Economic Commission for Europe**Inland Transport Committee****World Forum for Harmonization of Vehicle Regulations****Working Party on General Safety Provisions****101st session**

Regulation No. 46 (Devices for indirect vision)**Proposal for a supplement to Regulation No. 46****Submitted by the expert from the Netherlands***

The text reproduced below was prepared by the informal group on camera-monitor systems enabling the replacement of all mirrors by camera-monitor systems. It is based on document ECE/TRANS/WP.29/GRSG/2010/22. The modifications to the text of the Regulation, as amended by the draft 03 series of amendments (see document ECE/TRANS/WP.29/2011/106), are marked in bold for new or strikethrough for deleted characters. It incorporates the amendments proposed in ECE/TRANS/WP.29/GRSG/2011/5 which had been agreed upon during the 100th session of GRSG.

Figure 7:
~~Field of vision of Class IV wide-angle mirrors~~ **Class IV field of vision**

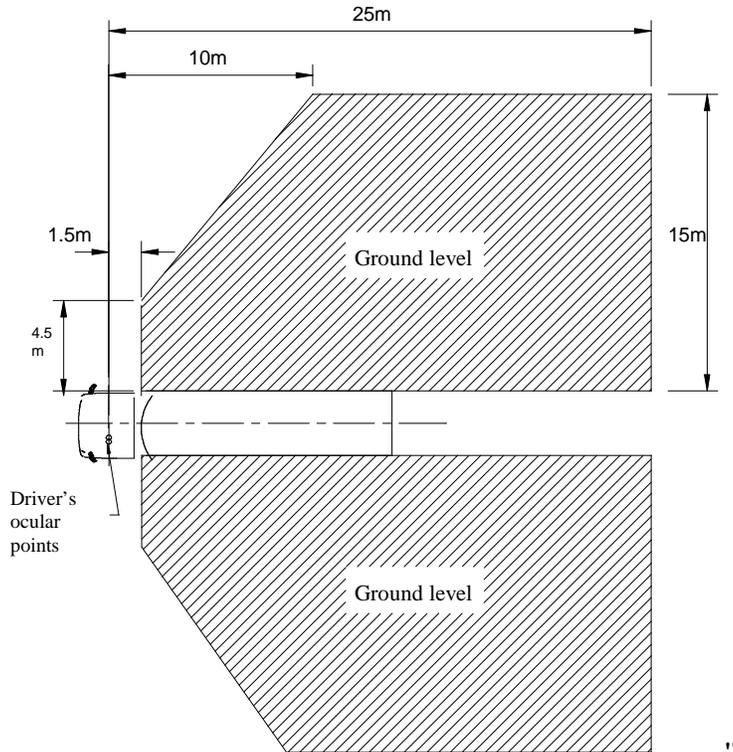
15.2.4.4.1. **Field of vision** ~~exterior mirror~~ on the driver's side
The field of vision ... driver's ocular points (see Figure 7).

- 15.2.4.4.2. ~~Field of vision exterior mirror~~ on the passenger's side
 The field of vision ... driver's ocular points (see Figure 7).

33. Align the text with the new definition of classes (para. 2.4.). Figure 7 has been corrected on the passenger's side so that the indicated dimensions are in correspondence with the front of the grey area.
